# ADDENDUM #2

February 4, 2026
CGMH NEW NUCLEAR MEDICINE SPECT/CT SUITE RENOVATION PROJECT
Job Number: 24-200
To: All Bidders, All Consultants, Project Manager
Number of Pages : 44

1 MECHANICAL PLUMBING PLAN - NEW WORK
M203 SCALE: 1/4" = 1'-0"

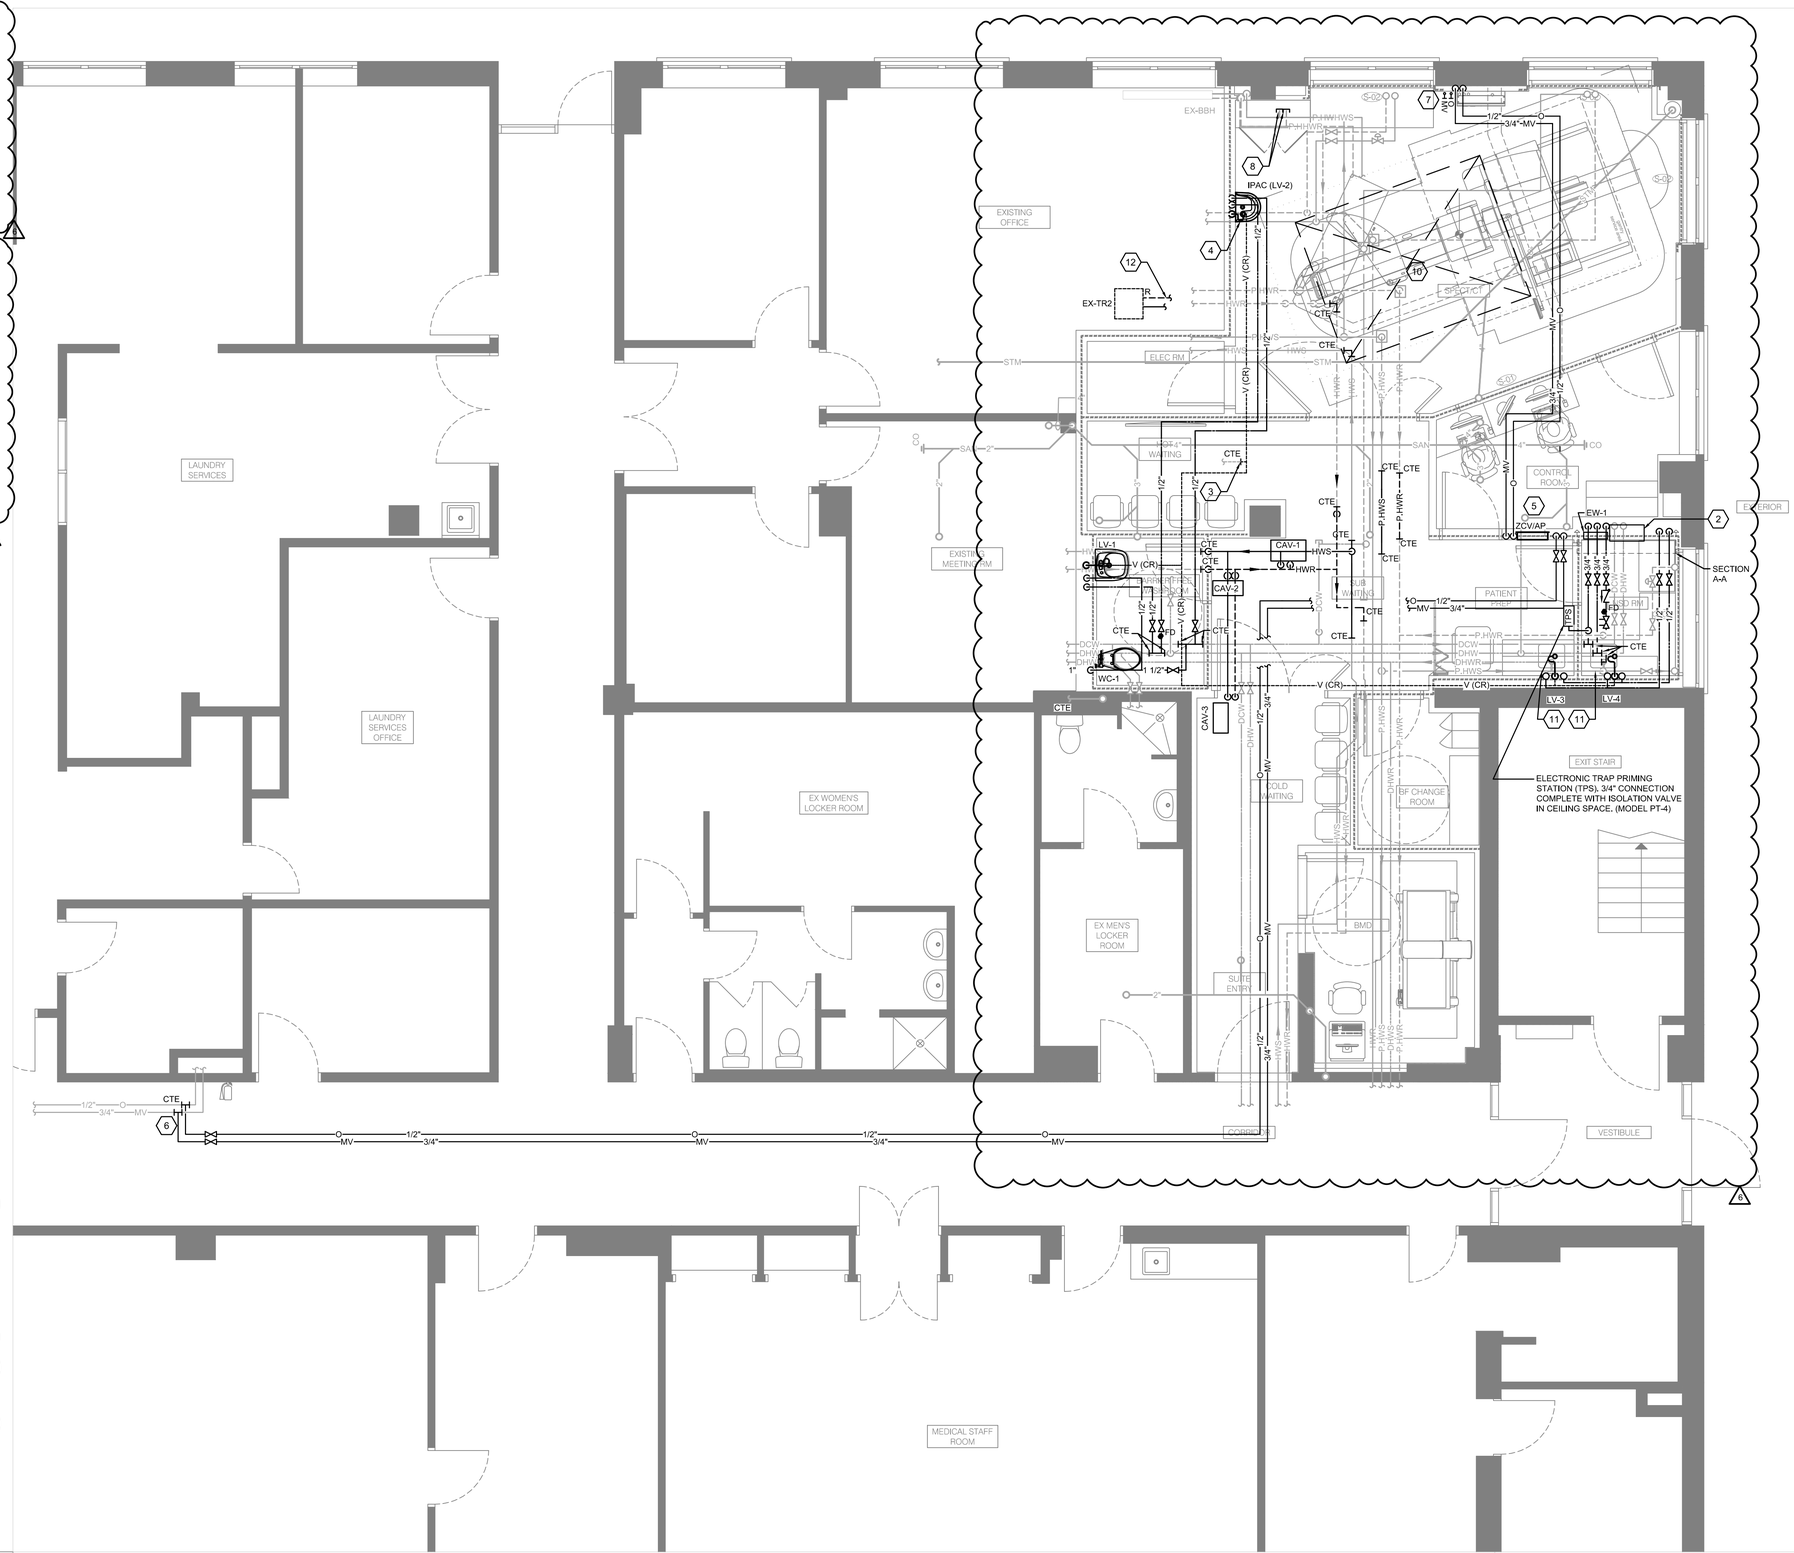
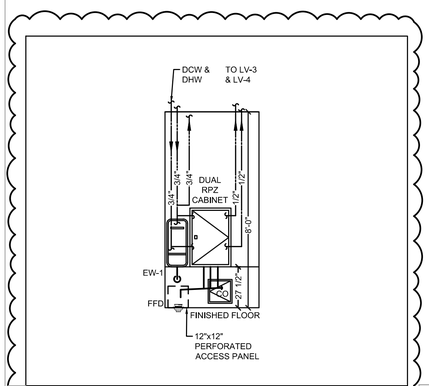
**4. Drawing M-203 – MECHANICAL PLUMBING PLAN - NEW WORK**

- Added general notes.

- Revised all new work notes.

- Added notes relating to chair lift structural coordination.

- Relabeled all LAVs to follow architectural tags, added clarification notes on scope of work for LV-3 / LV-4.

- Added existing Hydronic piping network to drawings, updated site layout for relevant plumbing lines and associated connection points.

- Added section A-A of NSD room north wall where eyewash and back flow preventers as shown on drawing.

- Revised medical gas route.

1 M300 MECHANICAL HVAC & FIRE PROTECTION PLAN - DEMOLITION
SCALE: 1/4" = 1'-0"

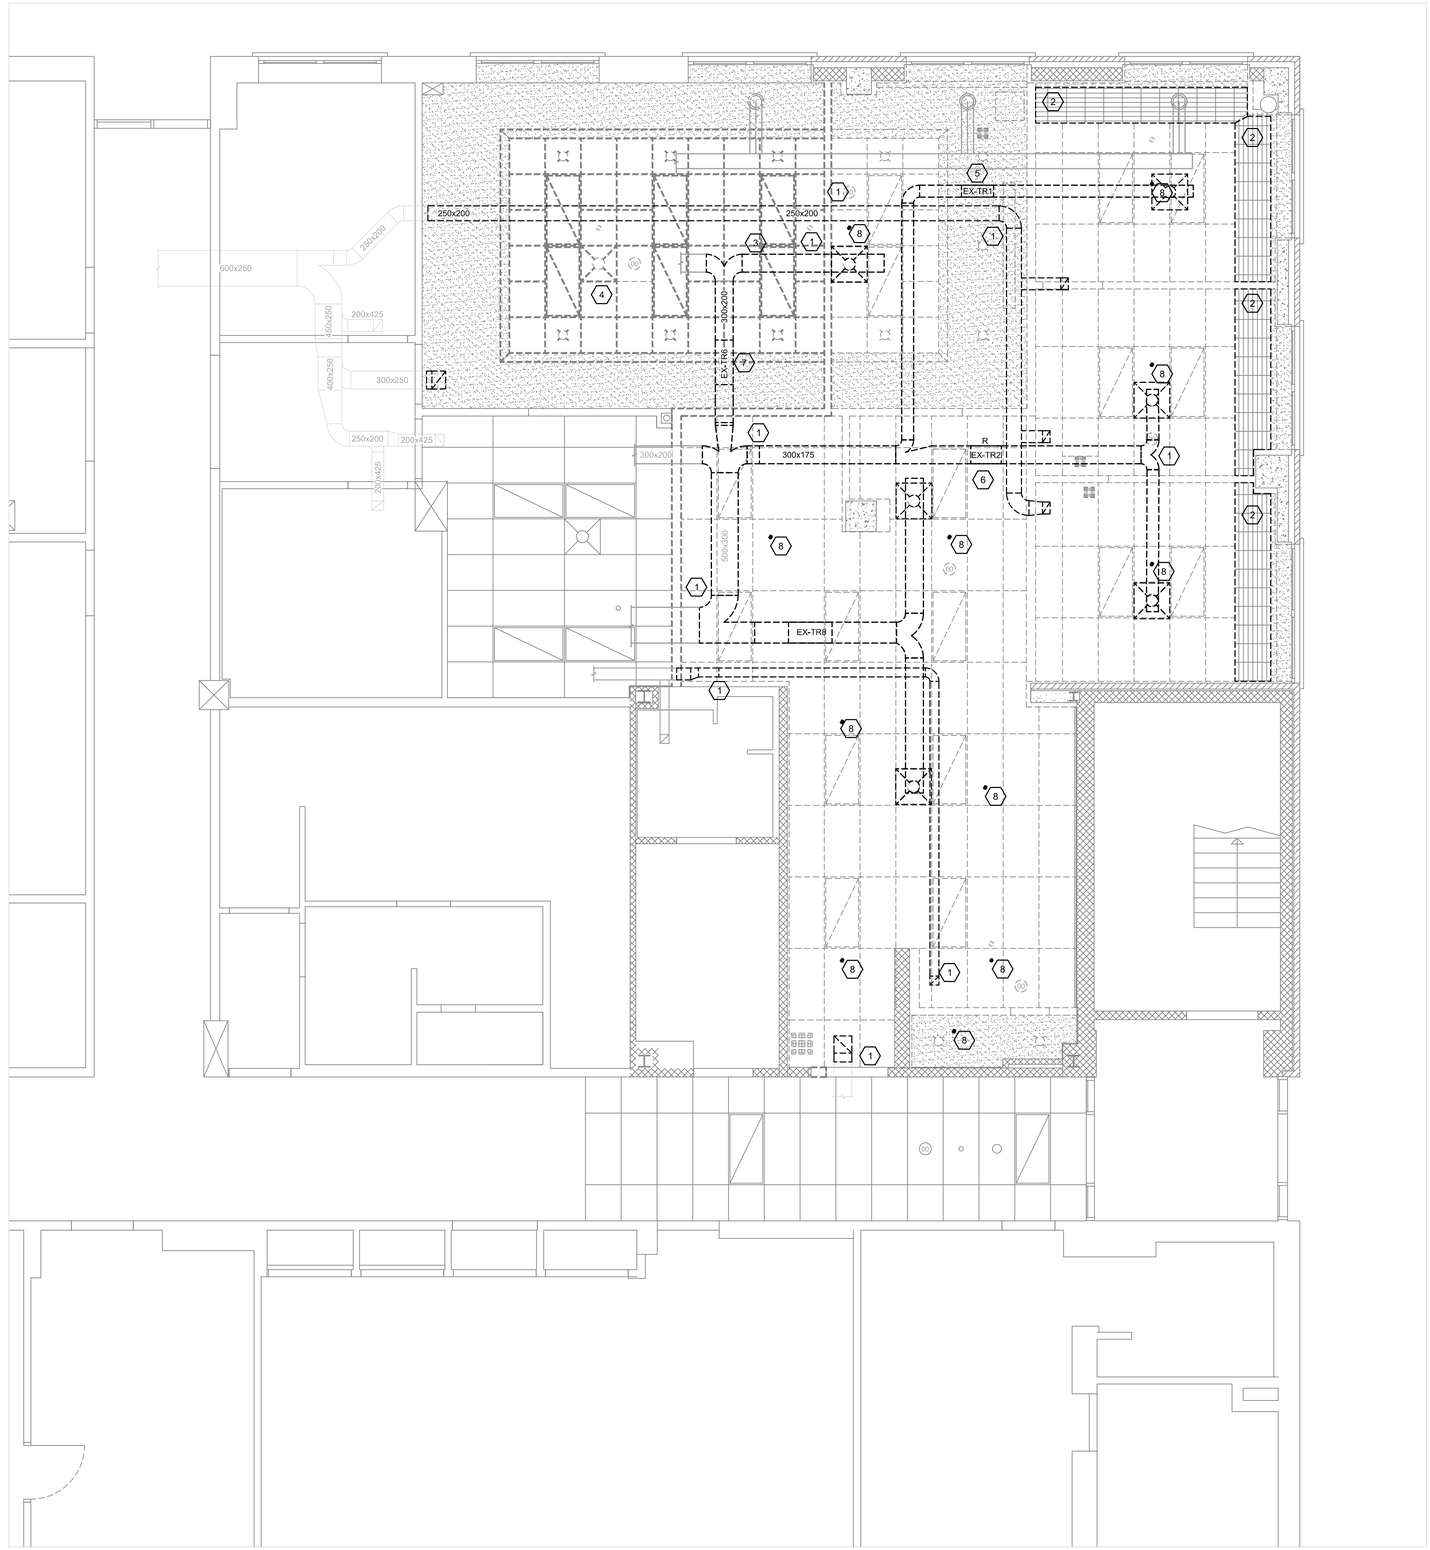
**Q3** On drawing M300, demo note 5 mentions an existing reheat coil to be removed. No 5 shown on the layout. Please issue in an addendum where this reheat coil is located.

**5. Drawing M-300 – MECHANICAL HVAC & FIRE PROTECTION PLAN -DEMOLITION**

- Revised drawing notes instructions relating to controls and room tags.

- Added tag 5 to drawing.

- Added relocated “R” tag to EX-TR2.

**Response:** Refer to changes to Drawings item 4.

1 M301 MECHANICAL HVAC & FIRE PROTECTION - NEW WORK
SCALE: 1/4" = 1'-0"

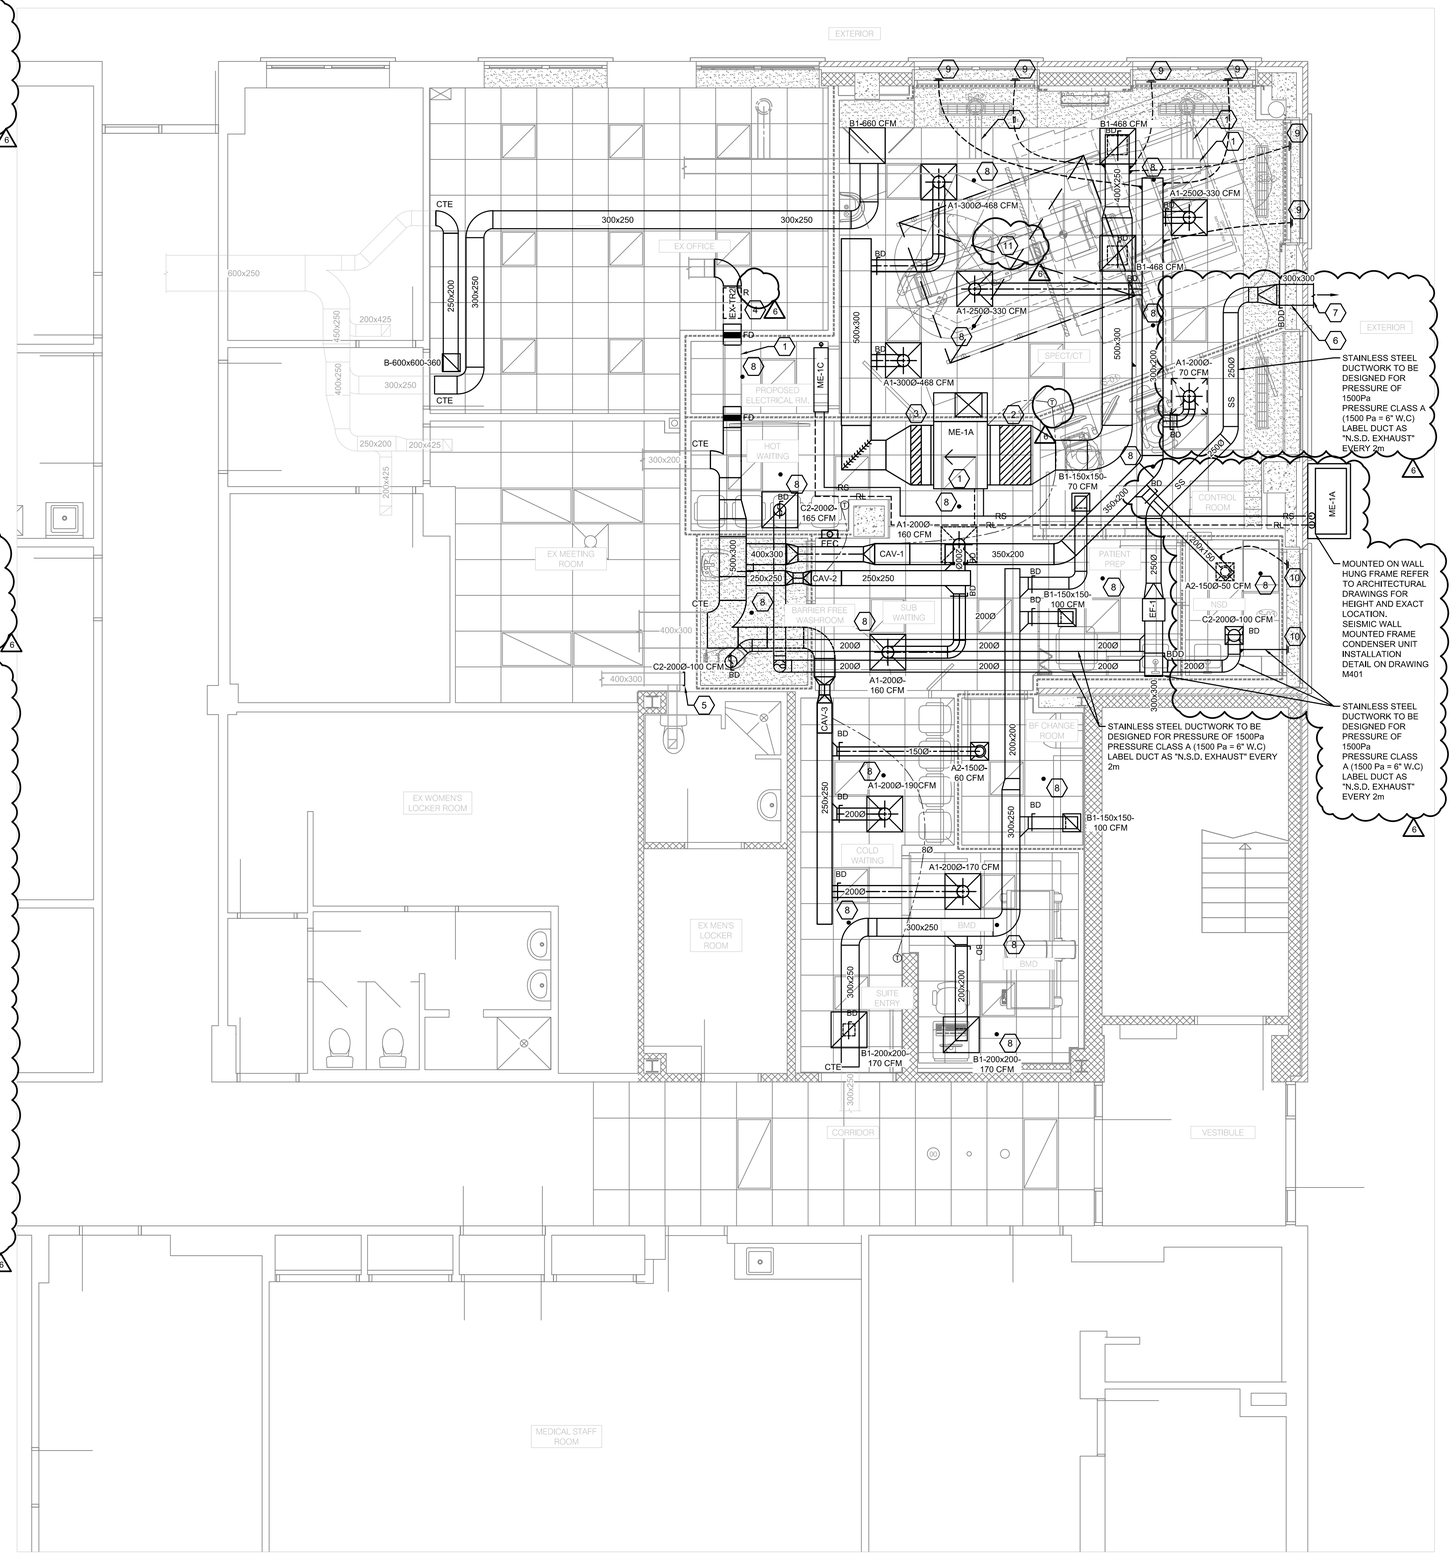
**Q4** On drawing M301, new work note 4 mentions to relocate a CAV box (EX-TR2) complete with piping. No piping mains or branches shown

**6. Drawing M-301 – MECHANICAL HVAC & FIRE PROTECTION - NEW WORK**

- Added general notes.

- Added fire protection general notes.

- Added notes relating to chair lift structural coordination.

- Added firestop note.
- Revised Control room ductwork arrangement as shown on drawing.
- Revised nsd ductwork arrangement as shown on drawing.
- Removed supply and return grilles from window bulkhead in control room and added to NSD room.
- Added not specific to NSD room window bulkhead airflow values.
- Revised exhaust duct material for window bulkhead in NSD room.
- Adjusted thermostat location for Spect CT room.
- Added fire extinguisher cabinet.
- Added additional drawing notes related to CU unit frame seismic requirement and exterior louvre.
- Added relocated "R" tag to EX-TR2.

**Response:** Refer to changes to Drawings item 4.

6 BACKFLOW PREVENTER CABINET DETAIL
SCALE: N.T.S

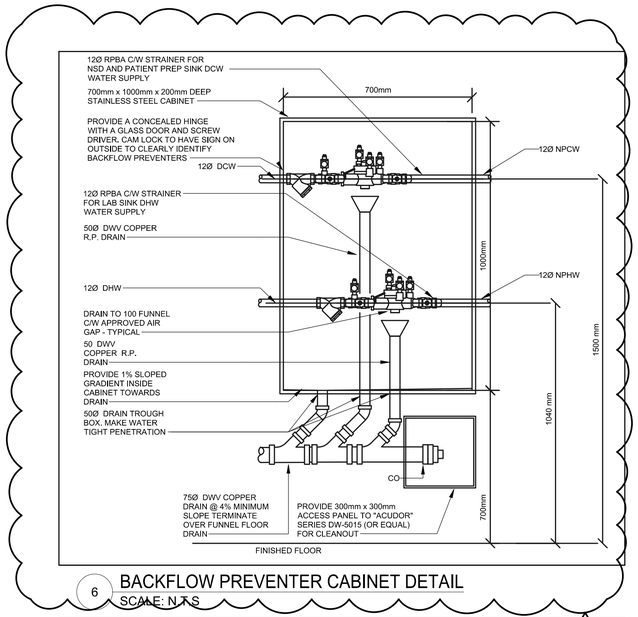
- Revised REDUCED PRESSURE ZONE ASSEMBLY DETAIL, removed expansion tank and revised drain arrangement as shown
- Revised HAND HYGIENE SINK (IPAC) INSTALL DETAIL, removed trap seal primer notes
- Added BACKFLOW PREVENTER CABINET DETAIL

1 REDUCED PRESSURE ZONE ASSEMBLY
SCALE: N.T.S

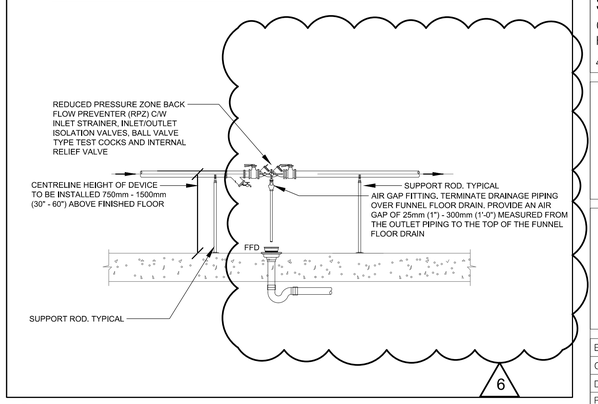
**Q11** Where to apply scope of work of Detail 1 of M-401 (reduced pressure zone assembly & expansion tank).

**Response:** Refer to changes to Drawings item 7.

1 E202 LIGHTING - NEW WORK
SCALE: 1/4" = 1'-0"

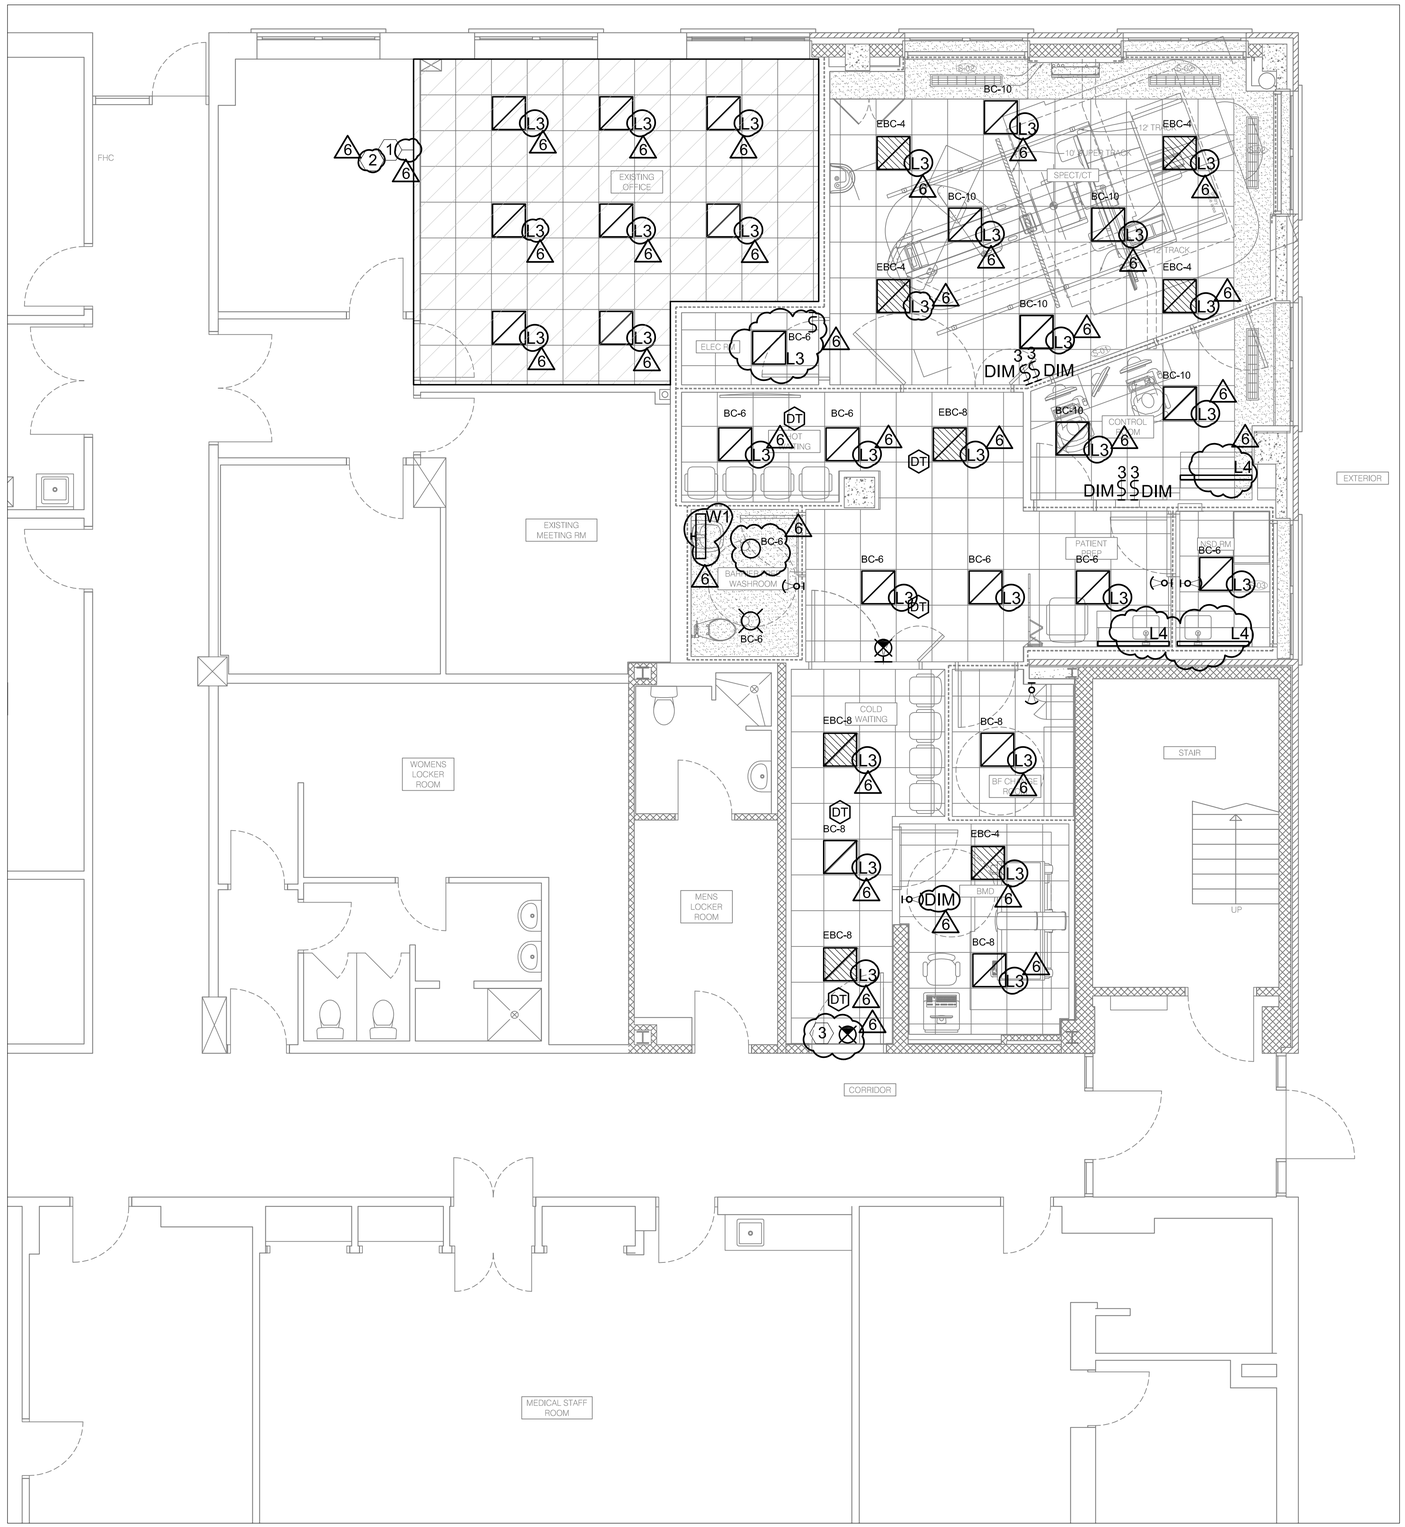
- Updated Tag.
4. **Drawing E-202 – LIGHTING - NEW WORK**
   - Included downlight to Barrier Free Washroom to match architecture rcp.
   - Added 3 under cabinet task lighting (W1) to Control Room, Patient Prep Room, and NSD Room.

- Specified lighting fixture type: L3.
5. **Drawing E-301 – POWER & SYSTEM - DEMO**
   - Included 1 receptacle, 1 emergency receptacle, and 1 data receptacle to be RR.
